CONVERSATION RECORD

ORGANIZATION Transnuclear, Inc.	DOCKET NUMBER(S) 72-1029
------------------------------------	-----------------------------

SUBJECT
RE: CoC 1029 Amendment 3 RAI 3-1 Request-weld

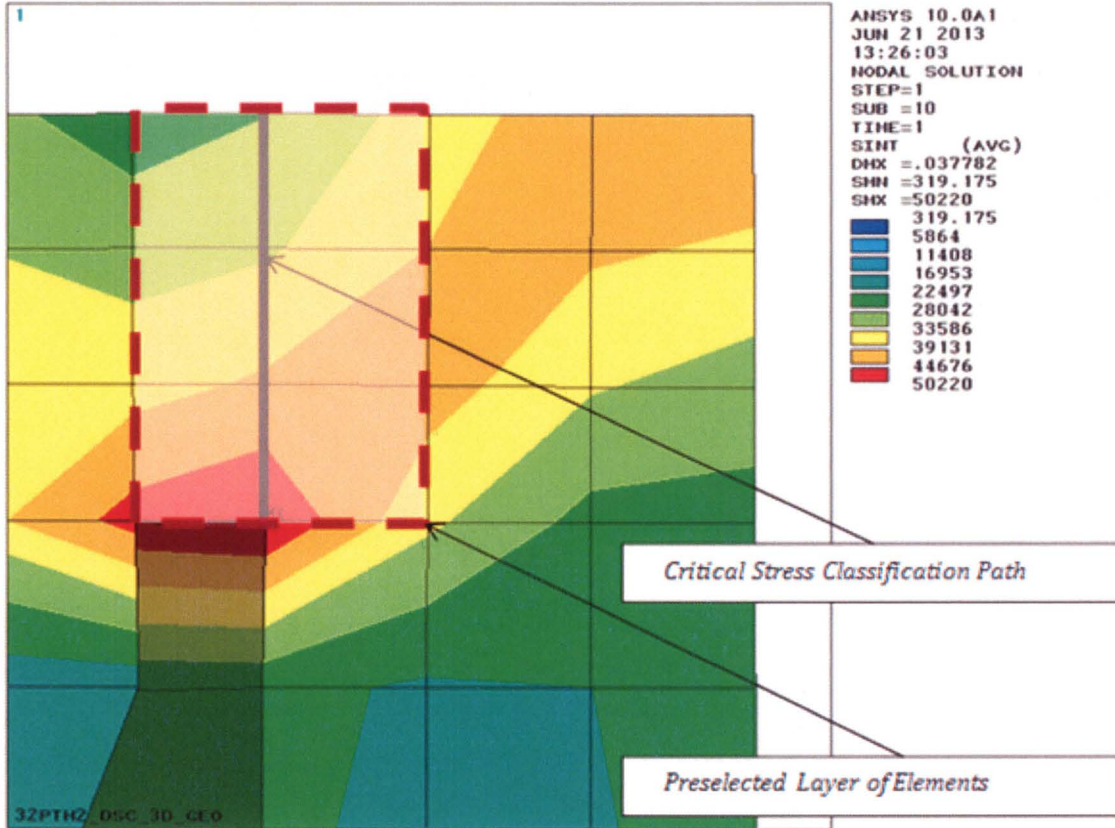
SUMMARY
Submittal augmenting the response in E-35274 CoC1029 Amd-3 submittal to NRC dated 6/10/2013, revised response to RAI 3-1, page 4, to illustrate that "The weld stresses are obtained after selecting only the 'weld' layer of element and the layer of adjacent elements.

Don,
Am I correct in characterizing this email submittal as augmenting the response in E-35274 CoC1029 Amd-3 submittal to NRC dated 6/10/2013, revised response to RAI 3-1, page 4, to illustrate that "The weld stresses are obtained after selecting only the 'weld' layer of element and the layer of adjacent elements?"

Yes, your characterization is correct.

Contrary to my previous email, TN is able to provide you the requested CoC 1029 Amendment 3 RAI 3-1 information today. The information is shown below. Should you have any further questions or need for information, please let me know.
